Thursday, June 10, 2021
10:00 am.

SUBDIVISION AUTHORITY AGENDA MEETING NO. 23

Subdivision Authority

MCKERNAN
 TENTATIVE PLAN SHOWING PROPOSED
SUBDIVISION
 OF
 LOT 12 & 13, BLOCK 12, PLAN 1367HW
 WITHIN THE
 S. 1/4 SEC. 30 - TWP. 52 - RGE. 24 - W. 4TH MER.
EDMONTON - ALBERTA

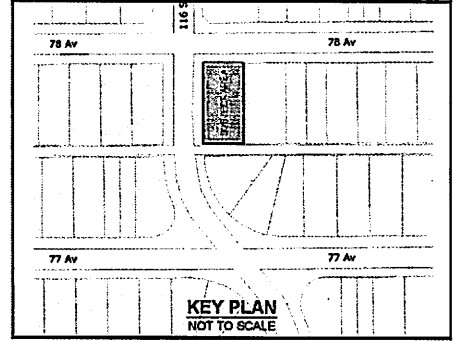
1. that the owner pay all outstanding property taxes prior to the endorsement of the plan of survey, and
2. that the owner dedicate road right of way for a 6 m x 6 m corner cut to the satisfaction of Subdivision and Development Coordination, as shown on the "Conditions of Approval" map, Enclosure II.

- Two sets of existing services (water and sanitary) enter the proposed subdivision approximately 10.0 m and 11.0 m east of the west property line of Lot 13 off of the lane. As per the EPCOR Drainage Services Bylaw and the EPCOR Water Services and Wastewater Treatment Bylaw, these services cannot cross the proposed property line.

- There is a deficiency in on-street fire flows adjacent to the property. City of Edmonton Standards requires on-street fire flows of 100 l/s for the current zoning. On-street fire flows in the area are below the required flow rate. The owner is advised to review on site fire protection.

TENTATIVE PLAN

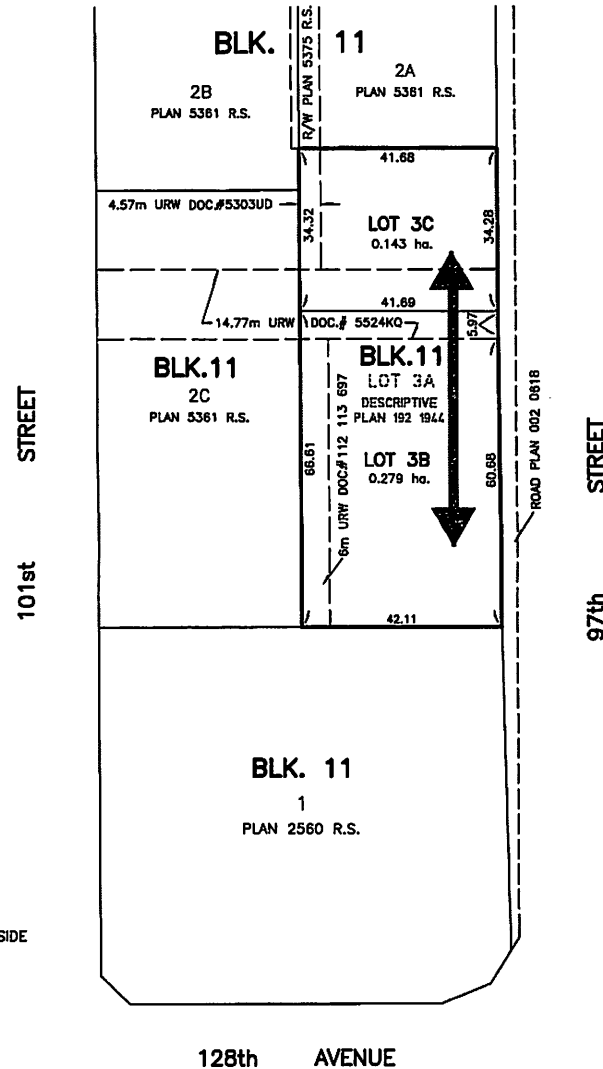
- Proposed Lot 3B
 - The existing water service enters the proposed subdivision within an existing Utility Right of Way (URW), approximately 5.6 m east of the west property line of existing Lot 3A. The URW is registered on Title under instrument number 5524KQ.

- An existing storm service enters the proposed subdivision within an existing URW, approximately 3.1 m east of the west property line of existing Lot 3A. The URW is registered on Title under instrument number 5524KQ.

- A second existing storm service enters the proposed subdivision within an existing URW, approximately 7.7 m west of the west property line of existing Lot 3A. The URW is registered on Title under instrument number 5524KQ.

- As per the EPCOR Drainage Services Bylaw and the EPCOR Water Services and Wastewater Treatment Bylaw, the aforementioned storm and water services cannot cross the proposed property line.

- Proposed Lot 3C
 - The existing storm service enters the proposed subdivision within an existing URW, approximately 7.7 m west of the west property line of existing Lot 3A. The URW is registered on Title under instrument number 5524KQ.

- The existing sanitary service enters the proposed subdivision approximately 1.2 m south of the north property line of existing Lot 3A off 97 Street NW.

- As per the EPCOR Drainage Services Bylaw and the EPCOR Water Services and Wastewater Treatment Bylaw, the aforementioned storm and sanitary services cannot cross the proposed property line.

REVISION 1: MOVED PROPOSED BOUNDARY TO SOUTHSIDE OF DRIVE ISLE.

TENTATIVE PLAN OF SUBDIVISION

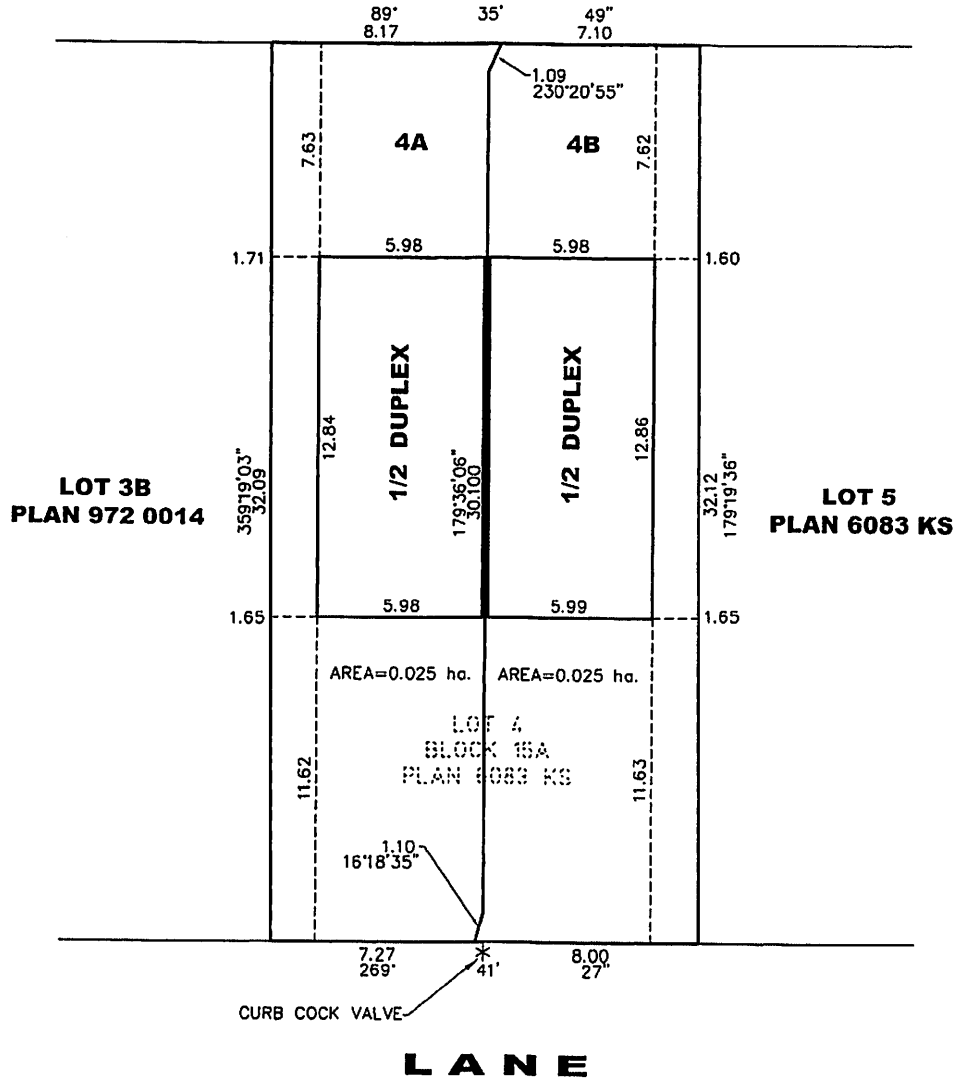
1. that the owner make arrangements to ensure that the private sewer services, storm water services, and water services for each unit are connected separately outside of the building, to the satisfaction of EPCOR Drainage Services and EPCOR Water Services Inc. If the services are connected separately outside of the building, the owner must ensure that they abide by the servicing conditions for buildings constructed prior to 1992 (please refer to Enclosure II);

2. that, subject to Condition #1, the owner make satisfactory arrangements with EPCOR Water Services Inc. to register against each lot an irrevocable caveat allowing for the operation, maintenance, excavation, repair or replacement of the water systems, sanitary sewer, and storm building sewers (please refer to Enclosure II). If the owner chooses to redevelop the property, they must ensure that each lot is separately serviced off of the mains. The shared servicing provisions outlined in Enclosure II will not apply if the property is redeveloped;

3. that the final plan of survey shall conform to the attached revised tentative plan; and
4. that the owner pay all outstanding property taxes prior to the endorsement of the plan of survey.

- Two existing water services enter the proposed subdivision approximately 7.0 m east of the west property line of Lot 4 off of the lane, and approximately 7.62 m east of the west property line of Lot 4 off of the lane. The existing sanitary service enters the proposed subdivision approximately 7.6 m west of the east property line of Lot 4 off of 101 Avenue NW. Upon future site redevelopment, or, if the conditions in Enclosure II cannot be met, these services cannot cross the proposed property line as per the EPCOR Drainage Services Bylaw and the EPCOR Water Services and Wastewater Treatment Bylaw.

NOTES :
 (1) PROPOSED SUBDIVISION SHOWN THUS
 (2) PLOT PLAN REVISED ON JUNE 3rd, 2021 TO SHOW DEFLECTION TO ACCOMMODATE WATER & SEWER LINE AND CURB COCK VALVE.

TENTATIVE PLAN

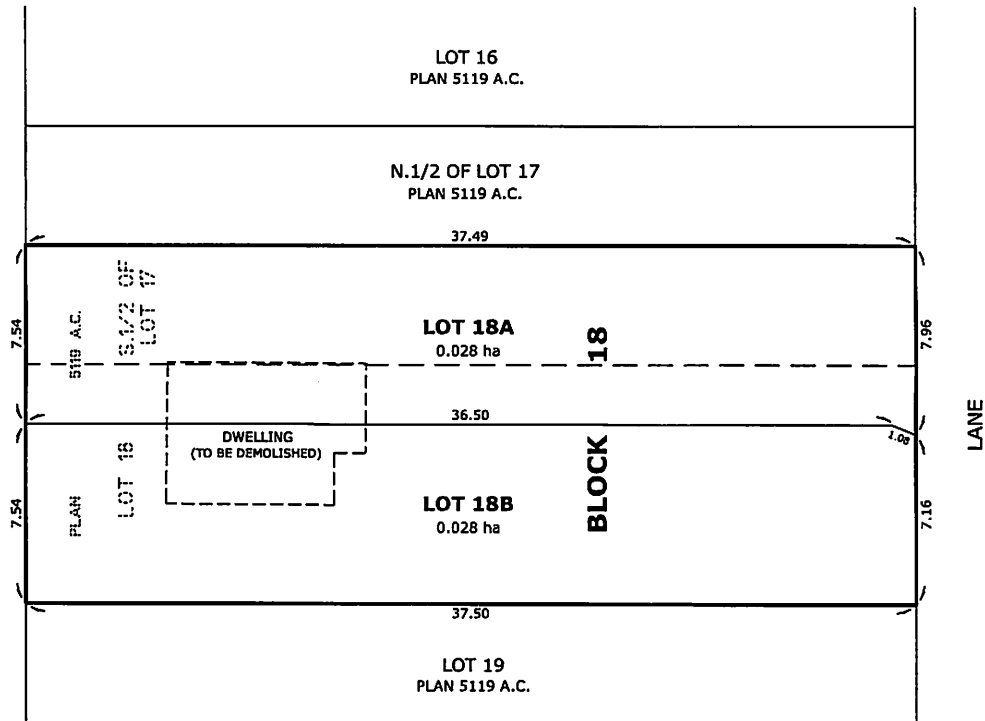
1. that the owner apply for a permit to demolish the existing dwelling prior to endorsement of the final plan. Demolition permits can be obtained from Development Services. Apply online at www.edmonton.ca/permits;
2. that the final plan of survey shall conform to the attached revised tentative plan; and
3. that the owner pay all outstanding property taxes prior to the endorsement of the plan of survey.

- The existing services (water and sanitary) enter the proposed subdivision approximately 22.52 m south of the south property line of 121 Avenue NW, off of the lane. As per the EPCOR Drainage Services Bylaw and the EPCOR Water Services and Wastewater Treatment Bylaw, these services cannot cross the proposed property line.

- There is a deficiency in on-street hydrant spacing adjacent to the property. The applicant/owner is advised to review on-site fire protection requirements to ensure adequate coverage (contact EPCOR Water at 780-412-3955).

TENTATIVE PLAN SHOWING PROPOSED
SUBDIVISION

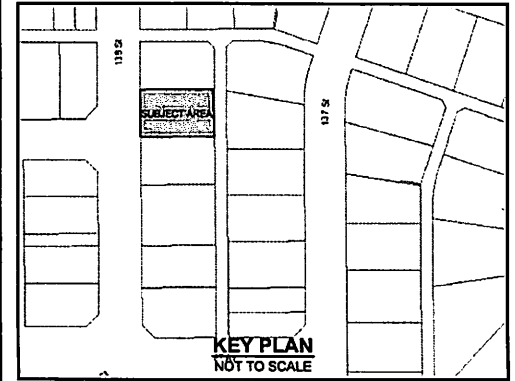
1. that the owner apply for a permit to demolish the existing dwelling and garage prior to endorsement of the final plan. Demolition permits can be obtained from Development Services. Apply online at www.edmonton.ca/permits; and
2. that the owner pay all outstanding property taxes prior to the endorsement of the plan of survey.

- The existing services (water and sanitary) enter the proposed subdivision approximately 12.2 m south of the north property line of Lot 7 off of the lane. The existing storm service enters the proposed subdivision approximately 11.4 m north of the south property line of Lot 7 off of 138 Street NW. As per the EPCOR Drainage Services Bylaw and the EPCOR Water Services and Wastewater Treatment Bylaw, these services cannot cross the proposed property line.

TENTATIVE PLAN

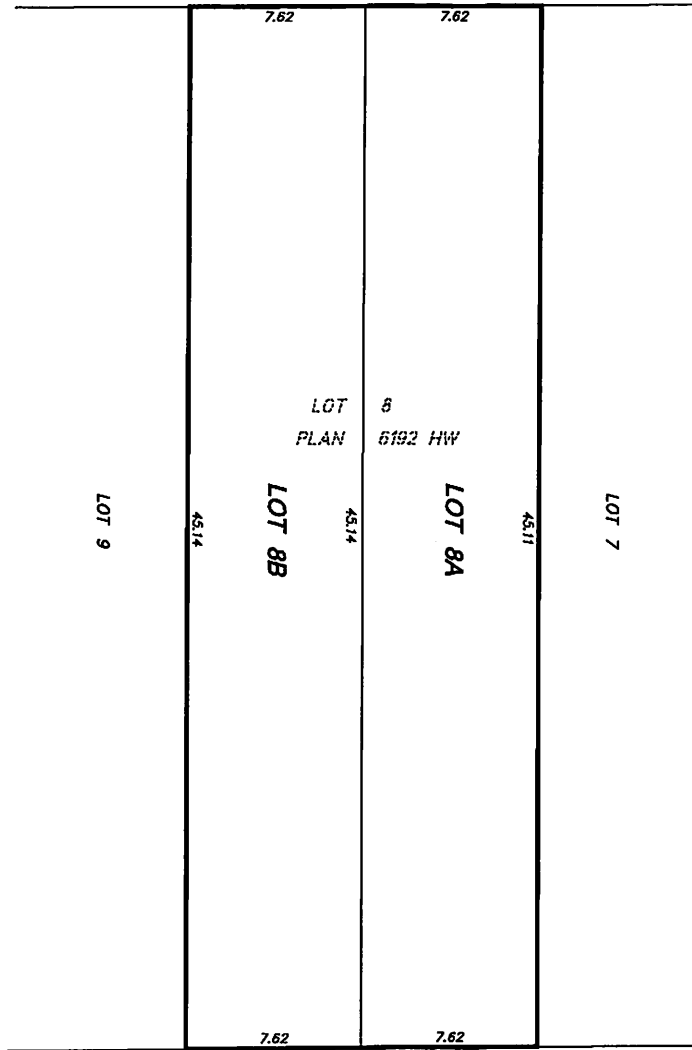
- Access for future development must be to the adjacent alley in conformance with Mature Neighbourhood Overlay Section 814.3(17) of the Zoning Bylaw #12800.
- There is an existing access to 161 Street NW. Upon redevelopment of proposed Lot 8, the existing residential access to 161 Street NW must be removed. The owner/applicant will be required to obtain a Permit to remove the access, available from Development Services. Apply online at www.edmonton.ca/permits.
